## **ADDENDUM NUMBER 1**

**PROJECT NAME: Repairs on SR93 (I-275) on the Sunshine Skyway Bridge in  
Pinellas/Hillsborough/Manatee counties.**

**FINANCIAL PROJECT NUMBER: 42348015201**

**DISTRICT CONTRACT NO: E-7G73**

**PHOTO 0-113: 205 R/CONC COLUMN**

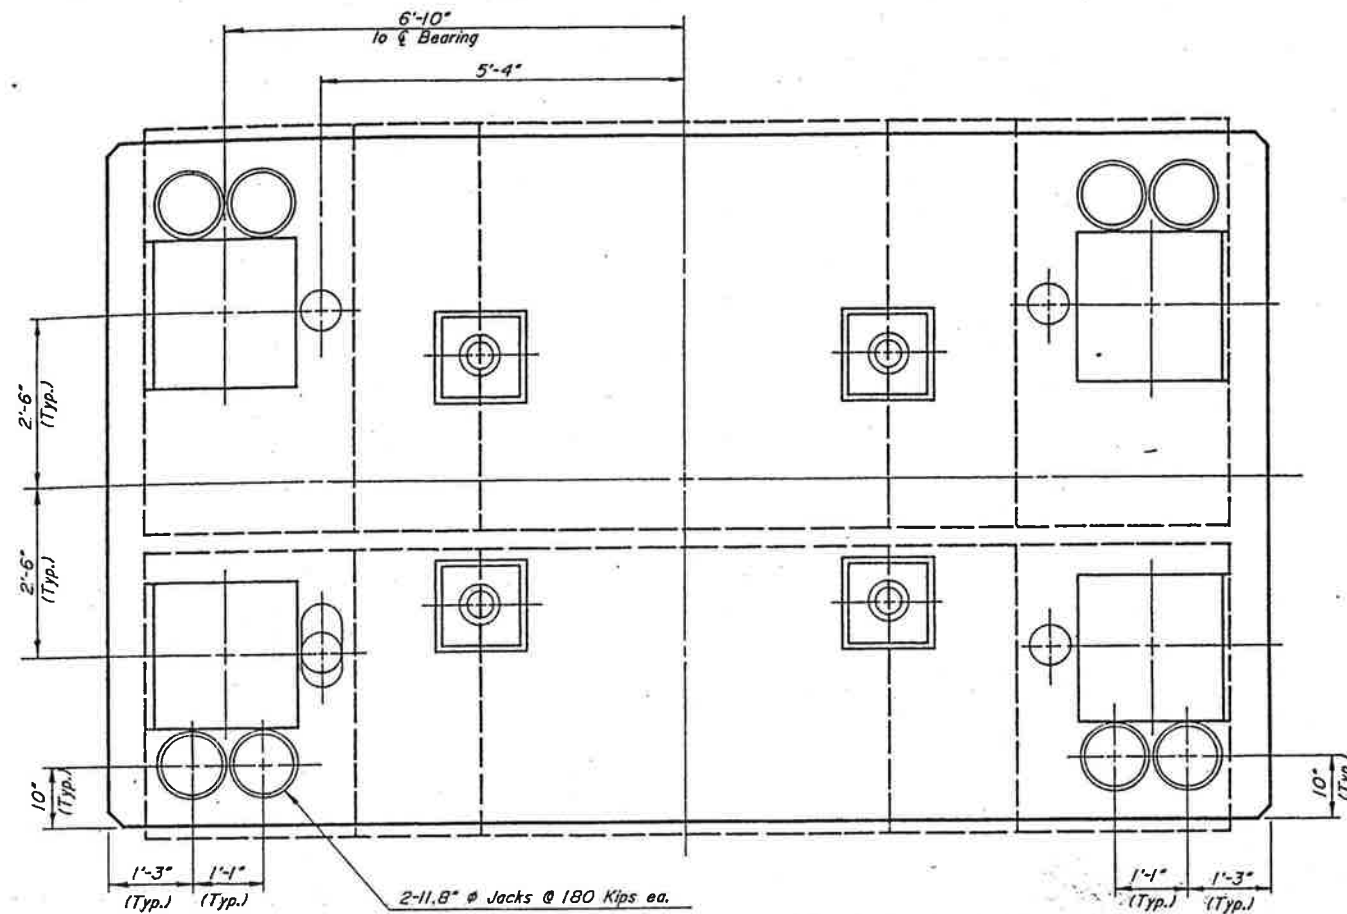
- 1) Please clarify location of debris in columns and estimated amount of debris.

Typical forming material left in-place at the top segment.

**Response:** *It is estimated that the total amount of existing construction debris in the columns is approximately 80 cubic yards and is mainly located in the four pylon columns at Piers 111 and 112. Further clarification of work is stated in Note J on Sheet B1-10.*

**Sheet B-3: Scope of Work item #2.** *The “removal of existing construction debris at bottom of columns in Piers 107 thru 116” shall be revised to “removal of existing construction debris attached to column interior walls and loose material at bottom of columns in Piers 107 thru 116.”*

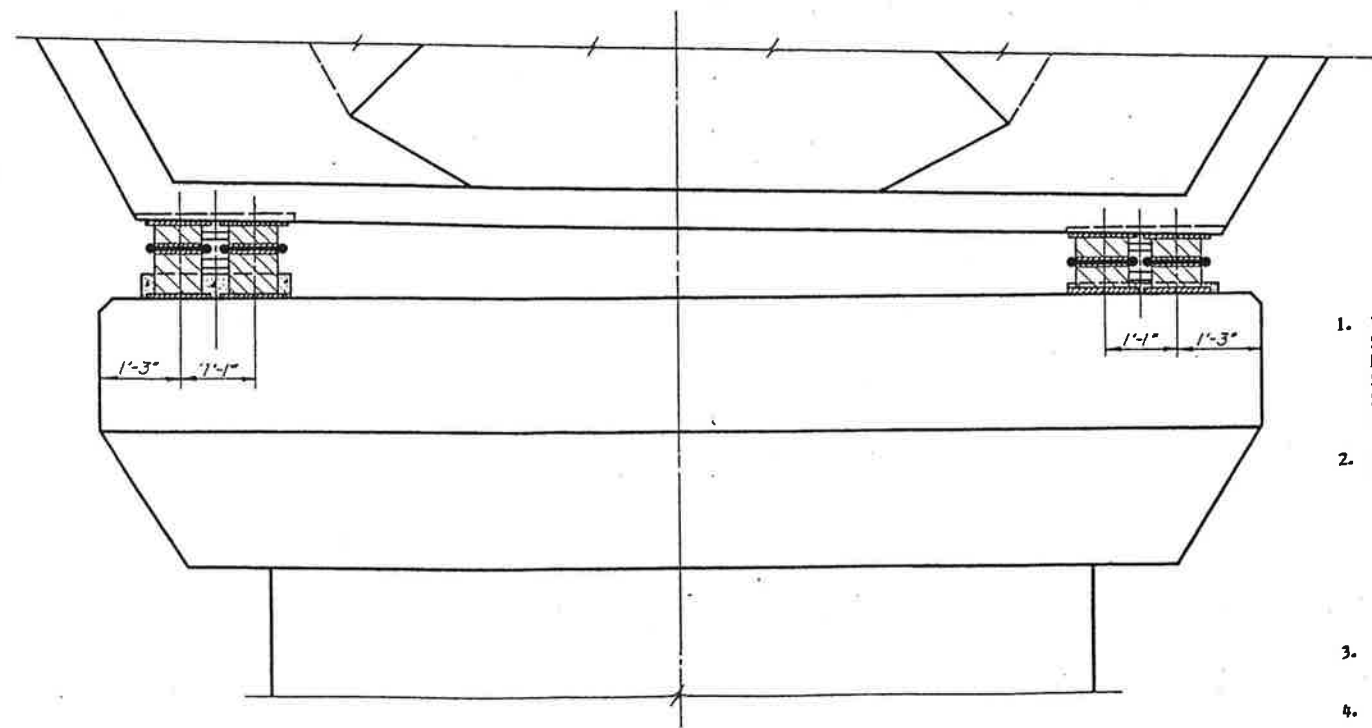
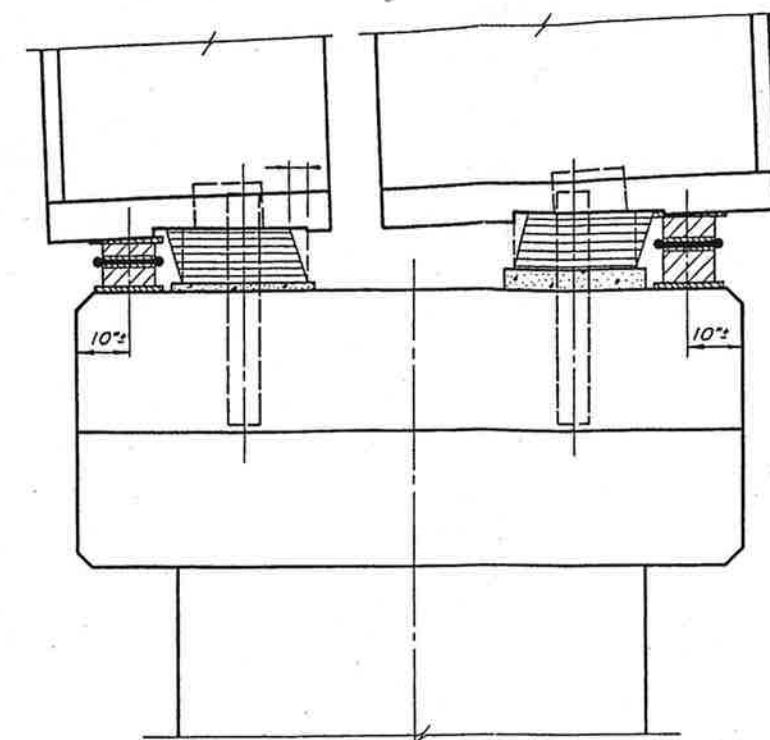
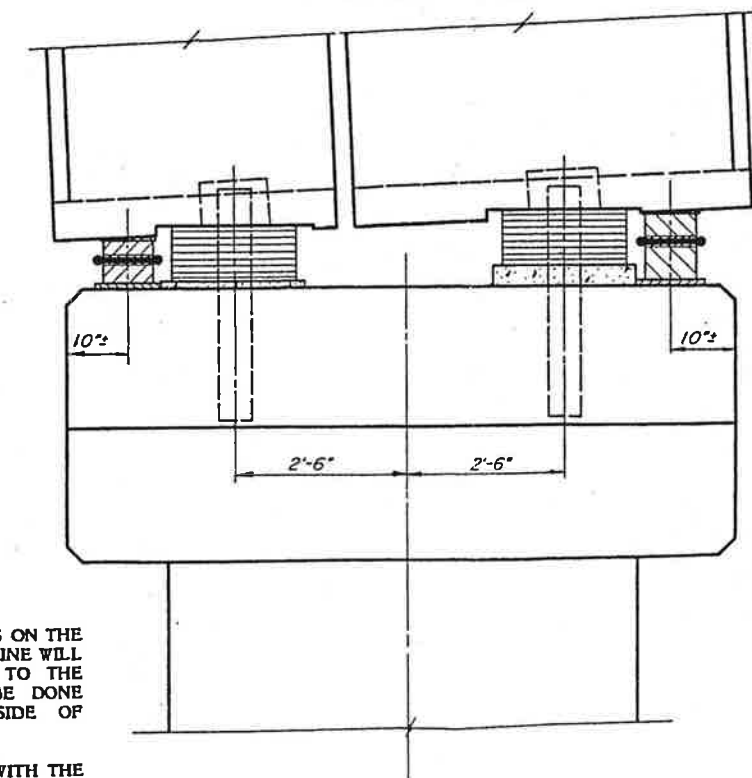
Part B. Does anyone have pictures for the jacking steel for the piers that was used the previous contract?

*A proposed Jacking Frame detail that was previously used is available for download at the following URL: <ftp://ftp.dot.state.fl.us/LTS/D7/d7bidquestions/423480-1/> However it should be noted that the contractor's jacking plans and calculations must meet the requirements of the specifications and plan notes (e.g. B-3, B1-29, B1-30 and B1-31).*
